CDM VALIDATION REPORT

**VALIDATION OF THE PROJECT ACTIVITY:
Electricity and heat Generating through a
cogeneration system in Gerencia Refinería
Barrancabermeja (GRB), Ecopetrol, S.A.**

AENOR REFERENCE: 2012/119/CDM/42

VERSION: 02.2

BASELINE SCHEME ENERGY GRB

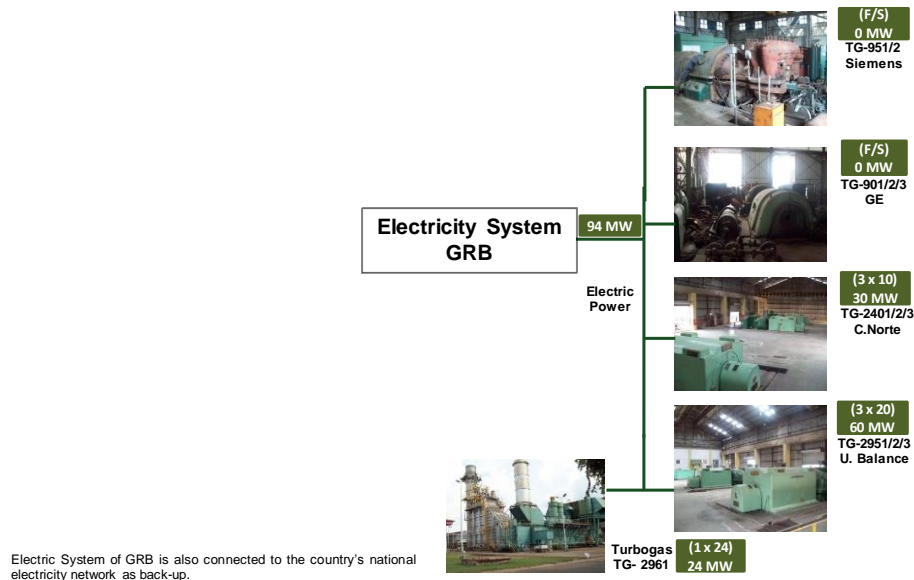
The electricity and heat of the project system in the baseline are not generated in a cogeneration facility. The baseline situation, heat and electricity generation in separate systems, has been checked against diagrams /20/ and visual inspection during the on-site visit. The audit team has confirmed that in the baseline scenario the steam is generated in existing steam generators, upgrade as needed (B- 901/2/3/4, B-951/2 y B-956) and the electricity is generated by the dedicated baseline power plants which are TG-2401/2/3; also these units are classified as total-condensation turbines in accordance with technical information from the operations area /11/12/. In addition, the audit team has validated that the heat and electricity of the consuming facilities that is not

The project activity displaces all electricity from baseline dedicated power plant (TG-2401/2/3) in accordance with diagrams stated in the PDD and technical information.

Sections A.3 and B.3 of the CDM-PDD have been modified in order to incorporate diagrams of baseline scenario and project scenario and description of emissions sources and GHGs included in the project boundary.	
DOE Assessment #1 <i>The assessment shall encompass all open issues. In case of non-closure additional corrective action and DOE assessments (#2, #3, etc.) shall be added</i>	The PP is requested to clarify the following issues: <ul style="list-style-type: none"> • Ensure that dedicated power plants will be no more operating once the project activity begins. • Monitoring of Volume of refinery gas consumed in cogeneration system is not required by the methodology. • Value of cogeneration heat supplied to industrial plant. CAR is not closed. 	
PP RESPONSE #2	<i>This section shall be filled by the PP.</i>	
<div>Corrective action</div>	<p>Dedicated power plant(s) (TG-2401/2/3, TG-901/2/3 and TG-951/2) will not continue operating along with the project activity cogeneration systems. At the time that the project begins, these equipment will be removed from the refinery operation.</p> <p>Refinery gas consumed in cogeneration system has been removed from the project scenario, so it is not necessary to be monitored directly in the monitoring plan.</p> <p>Value of cogeneration heat supplied to industrial plant (MCHO: 2,105,668 GJ) is calculated from cogeneration system heat output rate (CHOR: 246.6 GJ/h) and annual operating hours (AOH: 8,540 h/year).</p>

FINAL SCHEME PMSI, ENERGY SYSTEM GRB

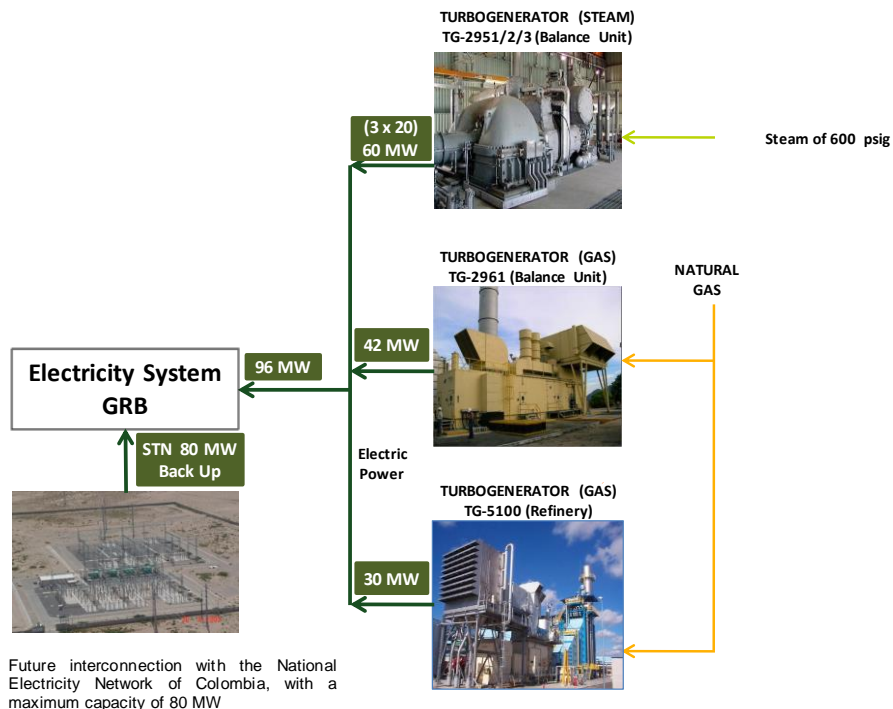
<i>It shall provide and indentified the evidences proposed (if applicable)</i>	<p>In order to clarify the description of the project activity, diagrams of baseline scenario and project scenario are included in section A.3 of the CDM-PDD. In addition, description in these sections has been clarified.</p>		
DOE Assessment #1 <i>The assessment shall encompass all open issues. In case of non-closure additional</i>	<p>The PP is requested to clarify the description of the project activity regarding the following inconsistencies:</p> <ul style="list-style-type: none"> Capacity of new cogeneration unit U-5100 (35 MW of TG-

<p><i>Evidences proposed</i></p>	<p>See PP response of CAR 2.</p>	
<p>DOE Assessment #2</p>	<p>Description of the project activity has been clearly stated in the PDD as per the technical evidence provided by the project participant.</p>	
<p>Conclusion</p> <p><i>Tick the appropriate checkbox</i></p>	<p>CAR/CL CLOSED</p> <p><input checked="" type="checkbox"/></p>	<p>To be checked during the first periodic verification <input type="checkbox"/></p>
